**PLANNED UNIT DEVELOPMENT
& SUBDIVISION STAFF REPORT****Date: May 15, 2014****DEVELOPMENT NAME**MLK Avenue Redevelopment Corporation Subdivision,
Resubdivision of Lot 1A**SUBDIVISION NAME**MLK Avenue Redevelopment Corporation Subdivision,
Resubdivision of Lot 1A**LOCATION**320 North Broad Street
(Northeast corner of North Broad Street and Congress
Street)**CITY COUNCIL
DISTRICT**

AREA OF PROPERTY2 Lots/2.8 ± Acres (Subdivision)
3 Lots/4.1 ± Acres (PUD)**CONTEMPLATED USE**Planned Unit Development Approval to amend a
previously approved Planned Unit Development to allow shared access between two building
sites and Subdivision Approval to create 2 lots by subdividing an existing legal lot.**TIME SCHEDULE
FOR DEVELOPMENT**

SITE PLAN

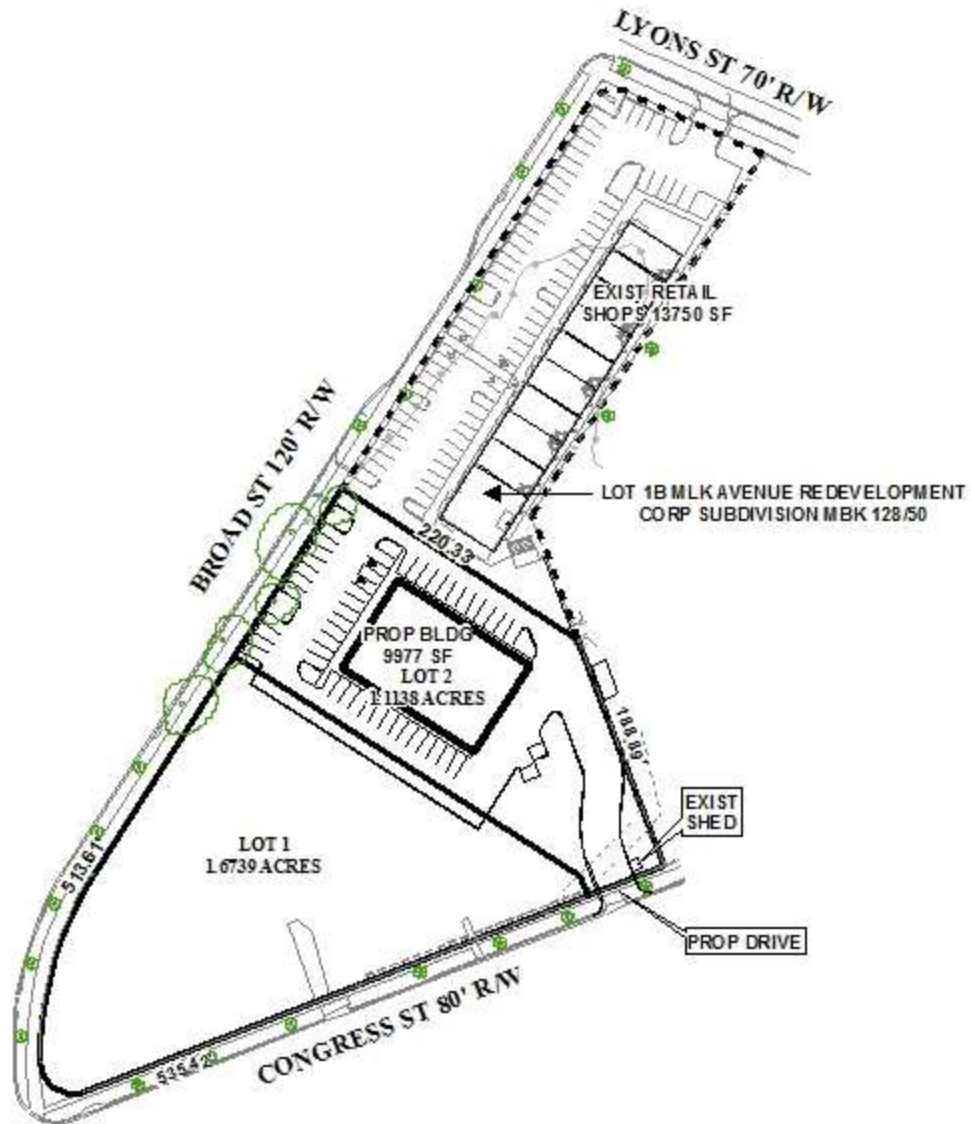
In accordance to the Subdivision Regulations, both proposed lots appear to exceed the minimum size requirements; however, the lot sizes in square feet and acres differ on both the preliminary plat and site plan. If approved, the preliminary plat and site plan should be revised to reflect the correct lot size in both square feet and acres.

All proposed parking areas for the proposed Lot 2 also appear to be compliant in terms of travel aisle width and parking stall dimensions; however, it should be pointed out that the proposed handicapped parking spaces appear to be substandard as it relates to City of Mobile standards, and should comply with the minimum standards set forth in Section 64-6. of the Zoning ordinance: all parking spaces should be a minimum of 9' in width, with accessible spaces additionally having an adjacent access aisle of a width applicable for regular and van accessible spaces.

Although the Planning Section does not enforce accessible parking or ADA, certain aspects of ADA do impact site design, and as PUDs are site plan specific, a revised PUD site plan should depict design compliance with the requirements of the ADA for all proposed accessible parking.

The site plan also shows proposed development on Lot 2 crossing the proposed lot line into Lot 1 with parking access aisle. The Lot line should be adjusted to include this in Lot 2.

Landscaping notes are included on the site plan; however, no new trees or landscaping are illustrated. The applicant has made reference to obtaining tree credits for two existing trees on the site, but the site plan does not depict any additional trees which may be required for compliance with the Zoning Ordinance. It should be noted that if there is a desire for credits for existing trees, the applicant should refer to Section 64-4.E.4. of the Zoning Ordinance. The site plan should be revised to depict full tree and landscaping compliance and identify any trees meeting the criteria which qualify for tree credits.

The PUD site plan and preliminary plat illustrate a 15' Fiber Optics Easement near the southwestern corner of the proposed Lot 2. If approved, a note should be placed on the PUD site plan and Final Plat stating that no permanent structure can be constructed in any easement.

It should also be pointed out that the site plan depicts a small 8' x 8' shed, also within southwestern portion of the proposed Lot 2. Photographic data confirms the portable shed was removed from the site between 2011 and 2013 and, as such, the site plan should be revised to reflect the removal of the structure.

- 1) Adjustment of the lot line between Lot 1 and Lot 2 so that all proposed development will occur entirely on Lot 2, and not cross over to Lot 1;
- 2) Revision of the site plan to depict the correct site and lot sizes in square feet and acres to coincide with the lot sizes on the Final Plat;

- 3) Revision of the site plan to illustrate compliant accessible parking spaces for the proposed Lot 2 and design compliance with the requirements of the applicable building code section 1106 (and 2010 ADA Standards for Accessible Design);

- 4) Revision of the site plan to identify any trees desired for tree credits and to reflect full compliance with Section 64-4.E. of the Zoning Ordinance regarding tree and landscaping compliance;

- 7) Revision of the site plan to reflect the removal of the 8' x 8' shed near the southwest corner of Lot 2;
- 8) Retention of sidewalks, proposed dumpster locations and associated notes on the site plan;
